Access Compliance Report Public Rights-of-Way (Curb Ramps)

Main Street: ROLLINGSTONE_LN		Cross Street: CHIRPING_SPARROW_WAY		Location:	SW
ADA ID: RPAT211008124608	Ramp Type: Type 4 - Parallel	Initial Pass/Fail: Pass	Overall Compliance: No	Severity Score:	2
Codes/Mitigation Info/Possible Solution			Field Measurements/Component Compliance

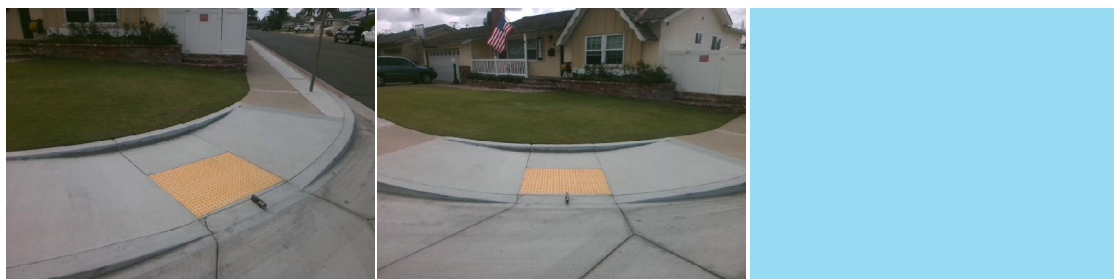
Crossing 1 Slope (%)	2.7		Crossing 2 Slope (%)	4.9
	Crossing 1 Cross Slope (%)	4.4		Crossing 2 Cross Slope (%)	1.7
Yes	Gutter Ponding	No	No	Curb Slope	14.2
Yes	Gutter Lip Height (in)	0		Road Run Slope (%)	3.2
Yes	Gutter Run Slope (%)	2.3		Road Cross Slope (%)	2.7
Yes	Gutter Cross Slope (%)	2.4	Yes	Perpendicular Joint Present	Yes
Yes	Overall Surface Condition	Acceptable			
	Cross Gutter Present?	Yes		Spandrel Present?	Yes
	Replace Cross Gutter?	No		Replace Spandrel?	No

Remove & Replace Curb Slope.

R304.2.2, STD 1115
